Welsh Subdivision

Brooklyn Turnpike & Pinch Street
Scotland, Connecticut

ENVIRONMENTAL

REPORT

FINAL SUBDIVISION PLAN
 PREPARED FOR
ROBERT WELSH JR
 BROOKLYN TURNPIKE PINCH STREET
 SCOTLAND CONNECTICUT
 SCALE 1"=100 APRIL 1985

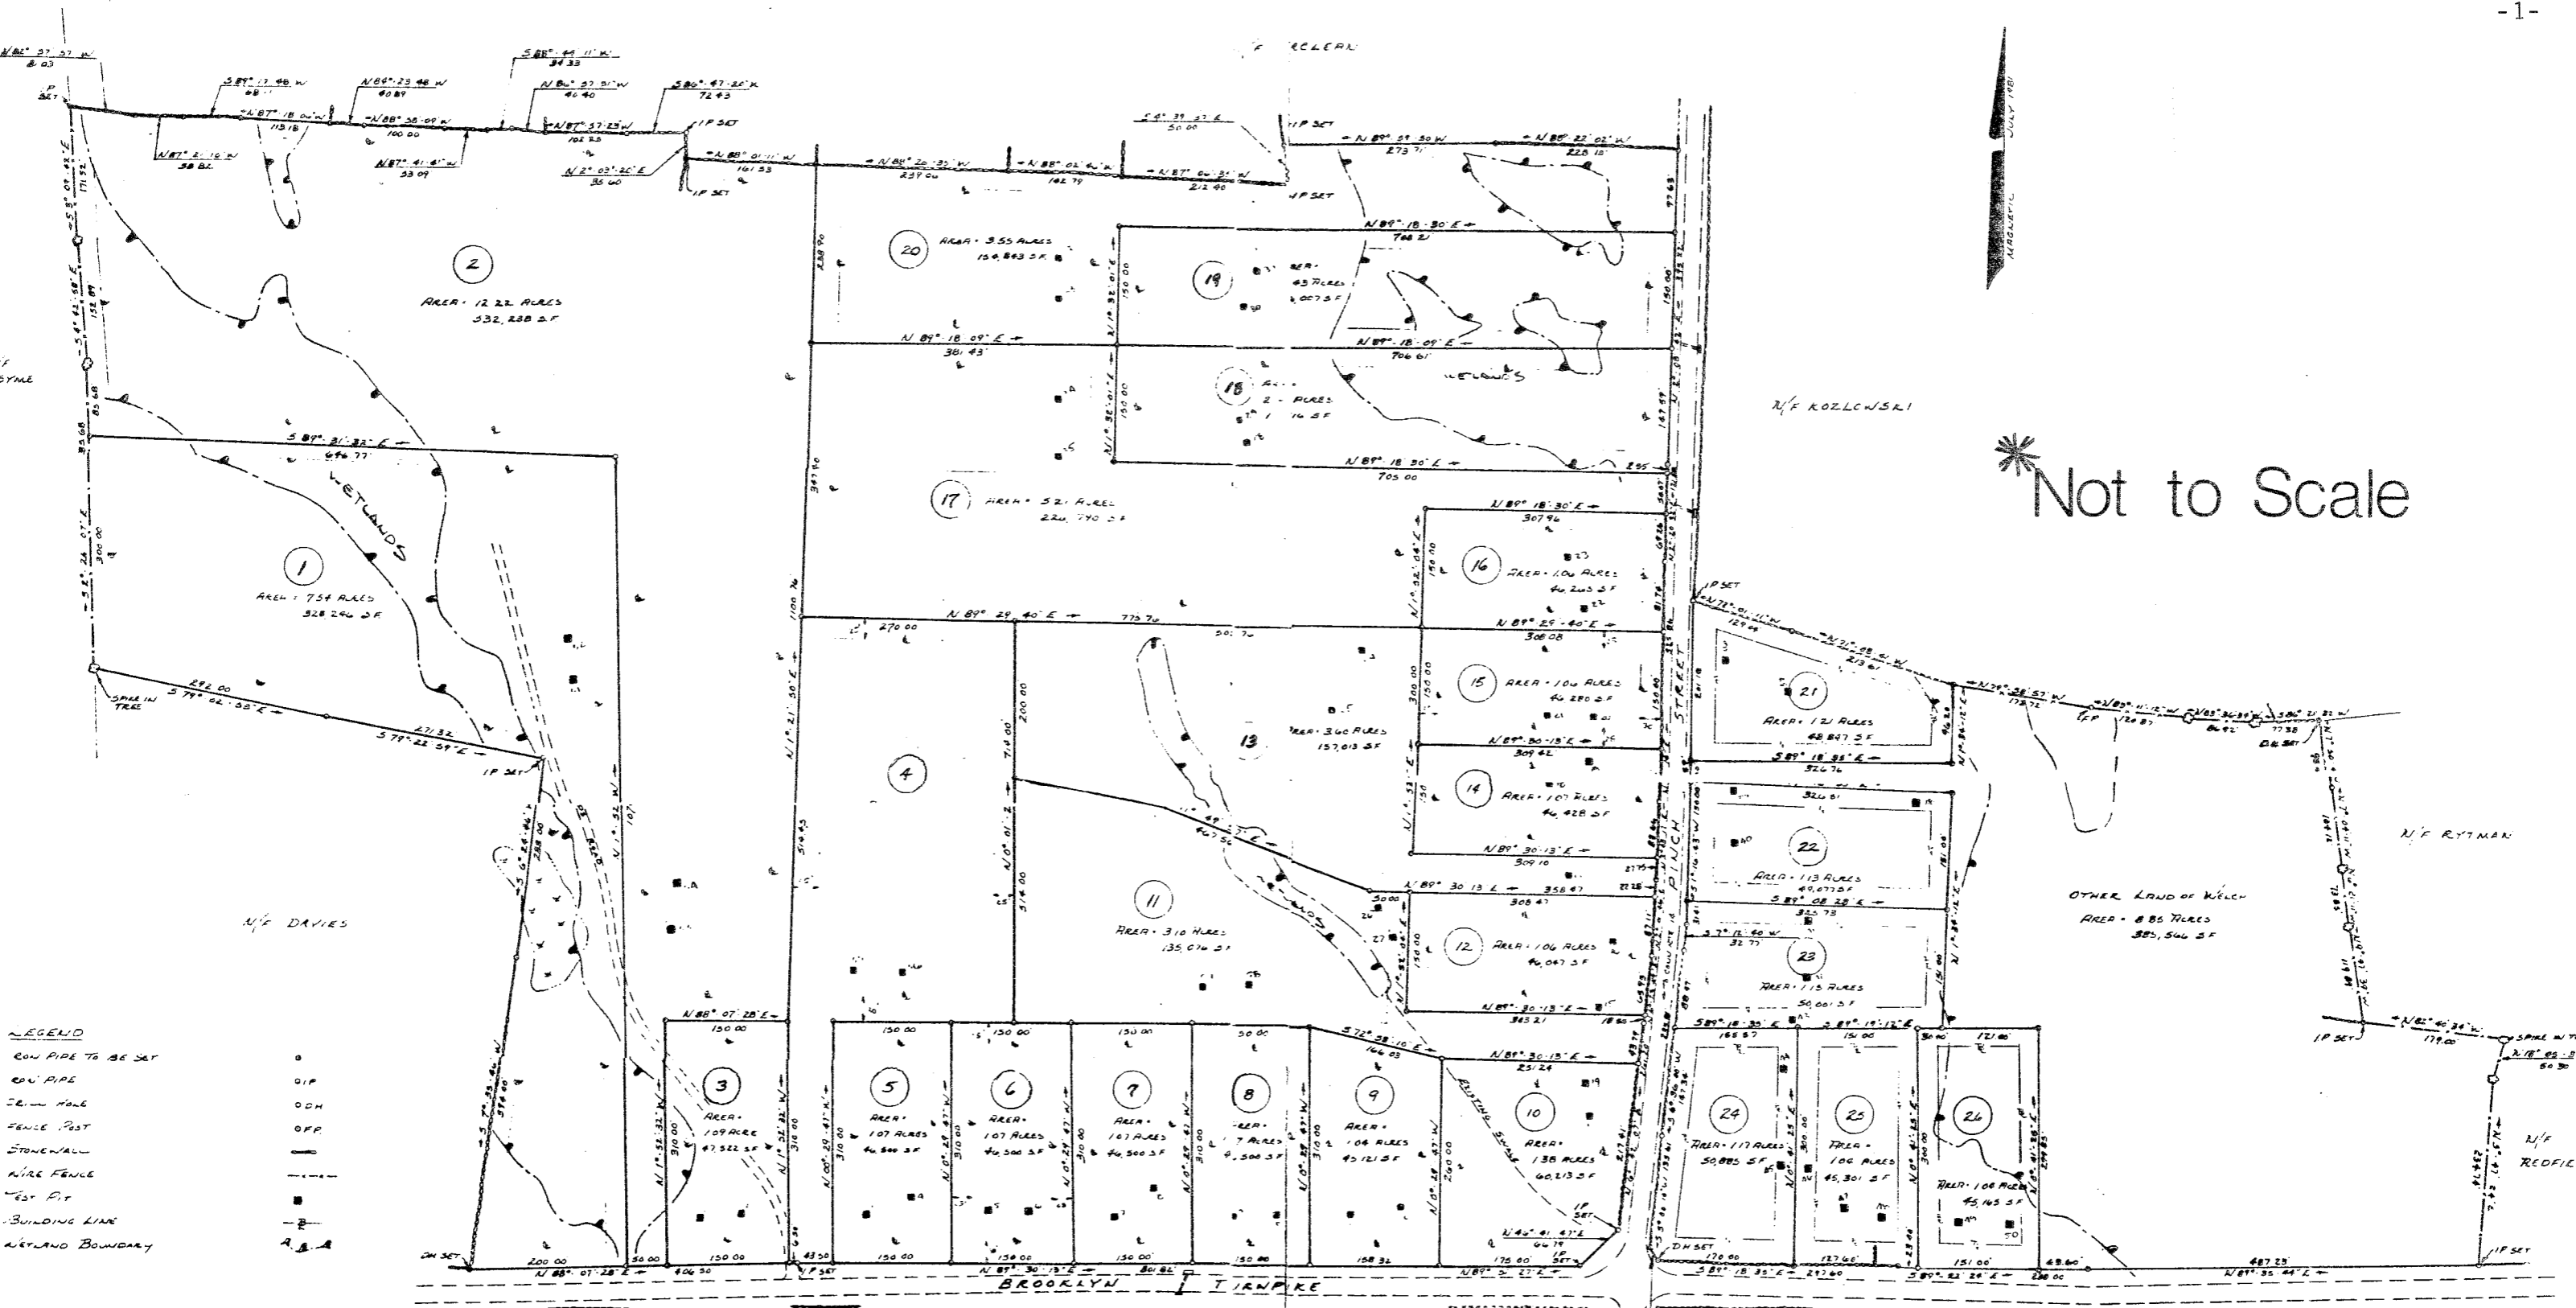
Another concern raised by Town officials on the review day is the need of the developer to cross wetland areas with access drives in the northern and western parts. Based on the site plan submitted to team members on the review day, it appears that wetland areas will be crossed in order to provide access to lots 18-20 and lots 1 and 2. Additional crossings of wetland soils by driveways may also be requested, depending on desired house locations.

The development plan shows access to lots 1, 2, 18, 19, and 20, by crossing wetlands. Since crossing wetlands can require substantial gravel fill and/or installing a culvert there is obvious wetlands disturbance. It is recommended that crossings be minimized by either combining access drives (lots 1 and 2/19 and 20), or by moving lot boundaries. Eliminating lot 3 and using it for a ROW to lots 1 and 2 is possible. Where driveways cross wetlands with drainage a culvert size should be determined. Amounts of fill, placement, and final grading, as well as stabilization of side slopes (i.e., grassed, hay mulch, or woodchips, etc.) should be shown on the site plan.

Attention to storm drainage across lot 10 and through a culvert under the drive proposed for lot 11 is important. There should be a right-to-drain easement across lot 10. Either a pipe or open waterway needs to convey runoff across this lot. It may be possible to move the existing swale to parallel the lot boundaries to allow better use of the lot.

The site development plan calls for a diversion swale between lots 24 and 25 and 25 and 23. An alternative would be to pipe the uphill runoff under the front of lots 25 and 26, beginning the pipe near the road in the present wooded swale. If the swale is constructed as shown, the town needs an easement to be sure the swale is always kept clean and unblocked. Otherwise lots 25 and 26 could suffer. Either swale or piping needs to be designed to carry the storm drainage from the 24 inch dia. road culvert. A swale will probably need to be stone centered to carry the high velocity runoff without gutting-out. Design and installation drawings should be on the site plan.

Lot 10 should be referenced on the plan with a note regarding the existing swale and rights to drain. Land labelled "Other land of Welsh" adjacent to lots 21 thru 26 should contain a note stating that the parcel is not approved for building purposes at this time.

Proposed well locations for virtually every lot in the subdivision should be relocated so that the 75' setback distance required around the well does not fall onto adjacent lots. No statute requires this, but it is a proper planning technique.
